Date: May 28, 2009
To: Ching-Pi Wang, Supervisor, TCP Uplands unit
From: Jerome Cruz, TCP
Subject: Weyerhauser Mill E site, Everett

A 10 year Data Review Report was recently submitted by Associated Earth Sciences, Inc. on the Weyerhauser Mill E/Koppers site in Everett.

Technical and Administrative Review Comments on the Weyerhaeuser Mill E formal MTCA cleanup site, 515 East Marine View Drive, Everett, Washington - Memo dated March 24, 2006

Date: March 24, 2006
To: Ching-Pi Wang, supervisor, TCP
From: Jerome B. Cruz, TCP
Subject: Technical and Administrative Review Comments on the Weyerhaeuser Mill E formal MTCA cleanup site, 515 East Marine View Drive, Everett, Washington.

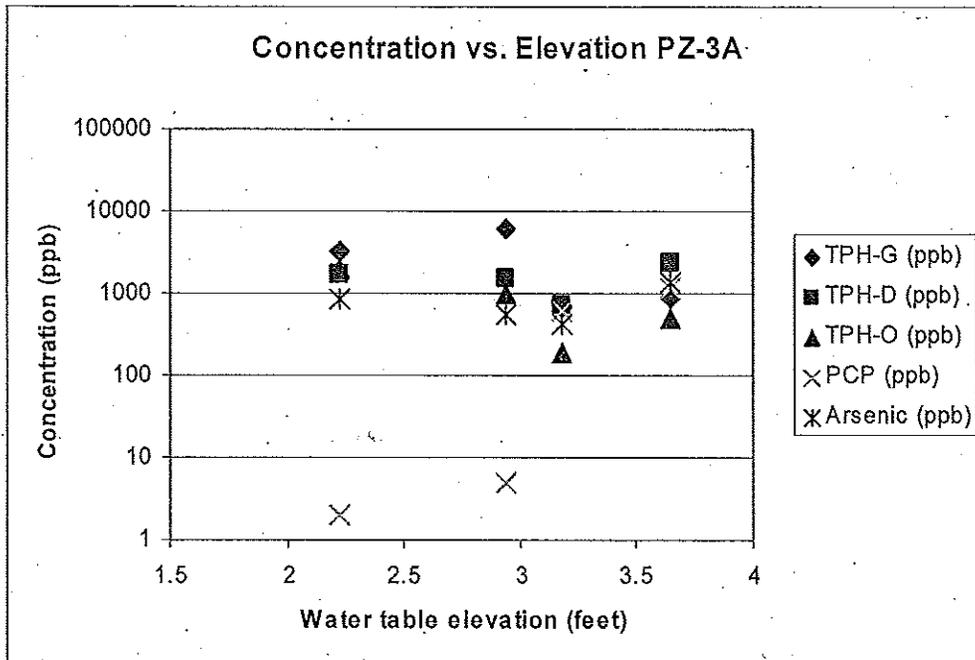
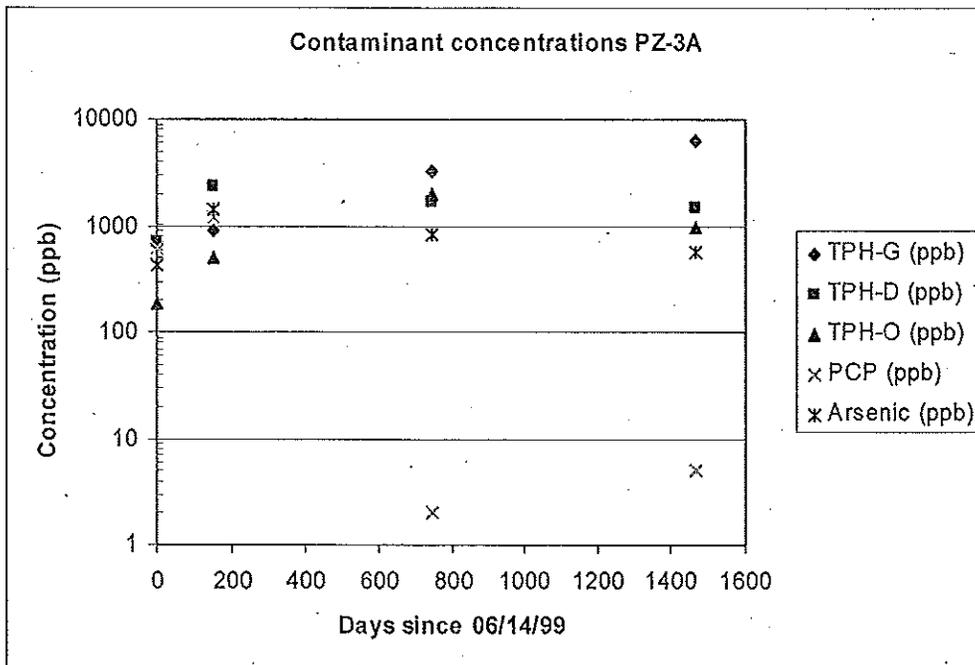
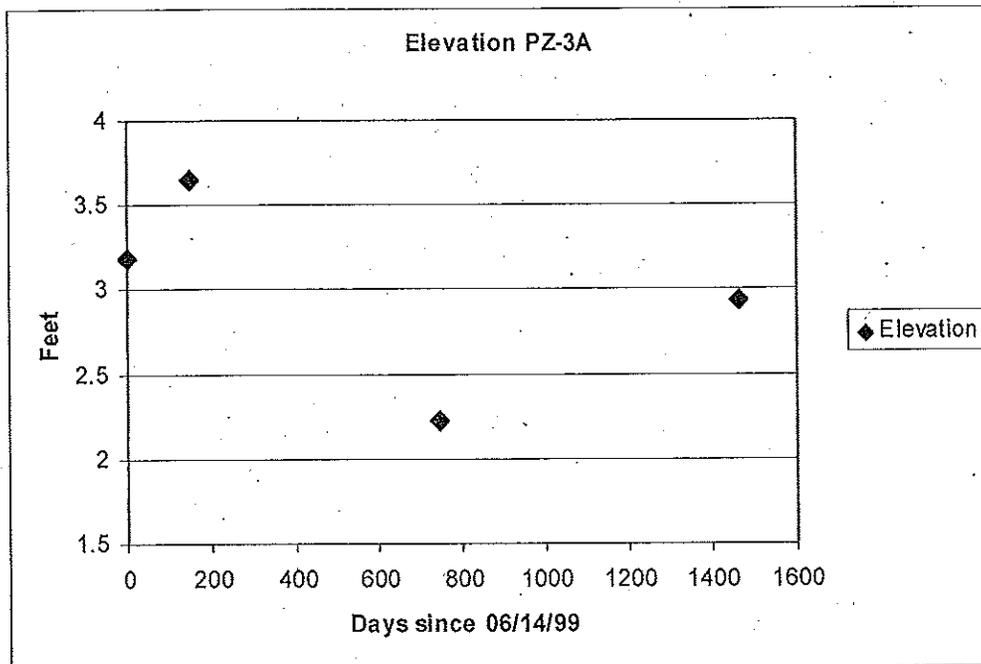
Figures 1 – 3 depict the water table and contaminant concentration trends in well PZ-3A. Figure 1 shows concentration vs. elevation. Figure 2 shows the change in concentration with time since barrier wall and cap installation, and Figure 3 shows elevation vs. time. Except for PCP, there does not appear to be large variations in contaminant concentration with water table elevation (figure 1). Figure 2 shows that there was a significant reduction in PCP with time. However, the time series plot of the hydrocarbon contaminant concentrations seem to show increases but with a leveling off with time since cap installation. This can imply essentially constant petroleum hydrocarbon source term loading and thus vertical contaminant loading to the lower sand aquifer continues to occur. Although it has been characterized as below the cleanup standard, it is unknown if this is a standard protective of water quality and aquatic organism in the river receptor. Arsenic remains above cleanup levels. Finally, the water table beneath the cap still shows fluctuation, although as expected it is much lower than the water table in the upper sand outside of the wall. Note that the other piezometer information is not plotted in this graph, but the total results may be found in the monitoring reports.
